Interconnection Feasibility Study Report GIP-IR578-FEAS-R1

**Generator Interconnection Request 578
30 MW Battery Energy Storage System Facility
Pictou County, NS**

2021-04-19

Control Centre Operations
Nova Scotia Power Inc.

Figure 2: Single Powerstage power capability curve³

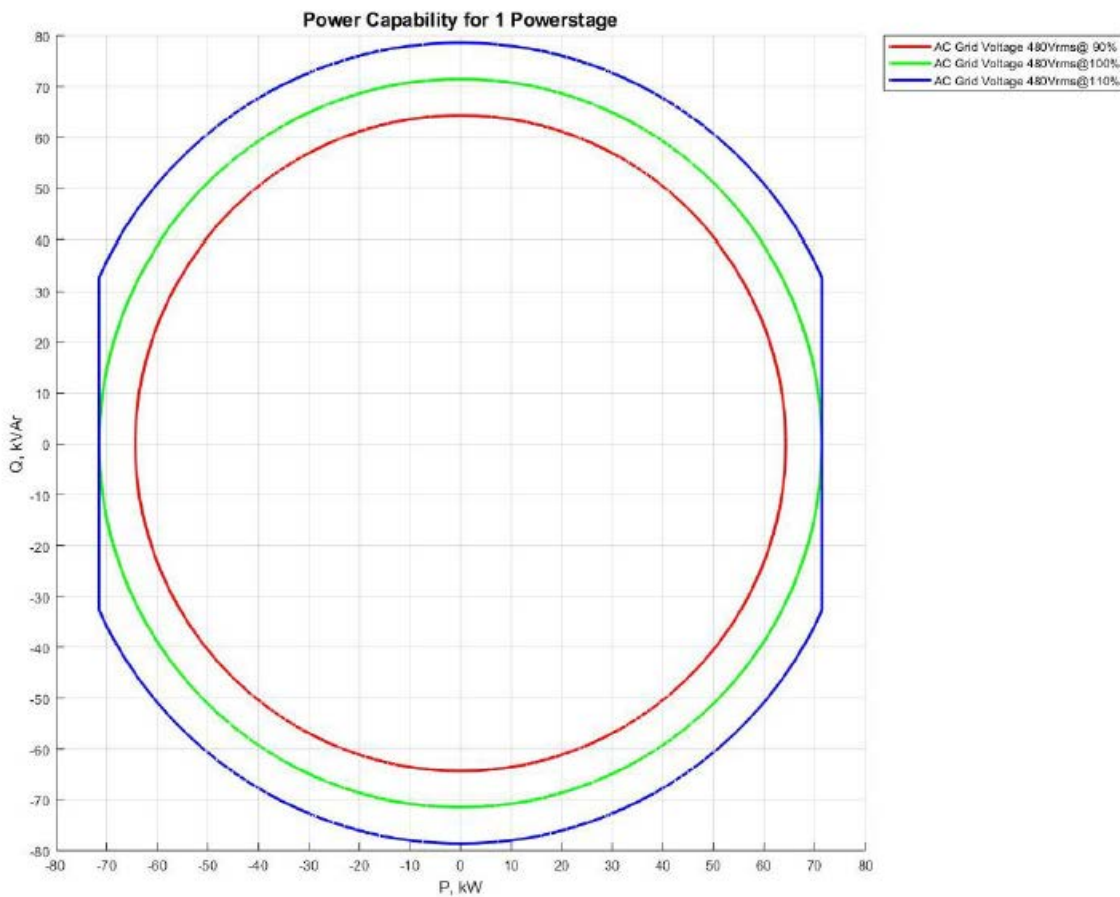
IR578's Tesla Powerstages use current-limited, bi-directional inverters, capable of full four-quadrant operation at nominal voltage; however, they are only capable of >0.99 power factor at full output. As a result, supplementary reactive support will be required at the low voltage terminals of the Interconnection Transformer to meet NS Power's requirements. The power capability curve for a single Powerstage is shown in Figure 2: Single Powerstage power capability curve.

Net power factor requirements for supplying VARs are met when the batteries are operating just below 27.5 MW (*11.99 MVAR supplied from the machine with 8.93 MVAR calculated at the high side of the ICIF transformer*). Table 5 lists the power factor calculated at the high side of the ICIF transformer for output levels from 30 MW to 25 MW, in 0.5 MW increments.

Supplementary reactive power support will be further investigated in the System Impact Study.

- a) Facilities to provide ± 0.95 power factor when delivering rated output (30 MW) at the 138 kV bus when voltage is operating between $\pm 5\%$ of nominal. Rated reactive power shall be available through the full range of real power output, from zero to full power.
